Council Agenda Correspondence

DATE: November 4, 2025

SUBJECT: ITEM #6b - PRADO INTERCHANGE AND BRIDGE VALUE ENGINEERING

Figure 15 – Segment 1 without barrier and with elevated shared-use path

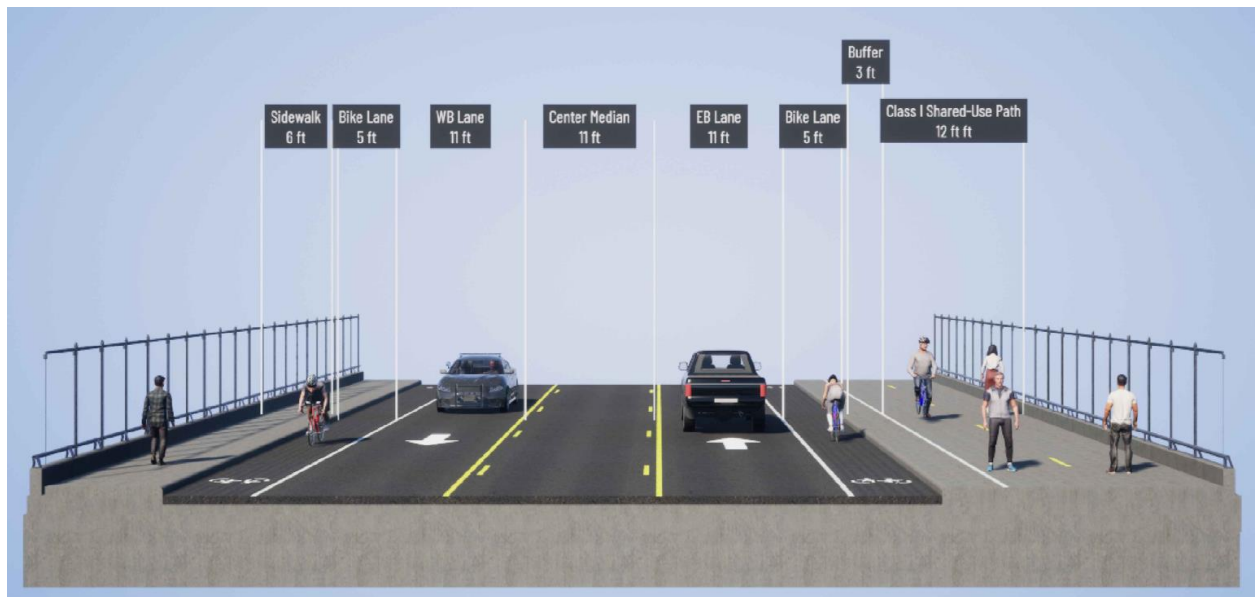
- 5) On California Blvd, at the end of the Pepper Street Bike Bridge, the city used metal fencing as the separator between car traffic and the shared use path. Would this be a potential material, rather than the k-rail pictured in the plans, for the separator on the whole stretch of the shared use path in this project?

Figures 8 and 9 of the staff report show a concrete K-rail serving as a barrier between the southerly shared-use path and the roadway. If the Council ultimately accepts staff's recommendation to reduce the design speed on Prado Road from 45 mph to 35 mph, current shared-use path design standards would no longer require installation of a physical barrier.

The Active Transportation Committee (ATC) expressed support through discussion (not a formal motion) to eliminate the barrier due to concerns that bicycle handlebars could come into contact with it. If the Council prefers to retain some form of separation, a metal fence could be considered as an alternative to the concrete K-rail.

Below are two additional figures not included in the staff report that represent what Segment 1 and Segment 2 might look like using an elevated share use path along the south side of Prado Road and removing the barrier.
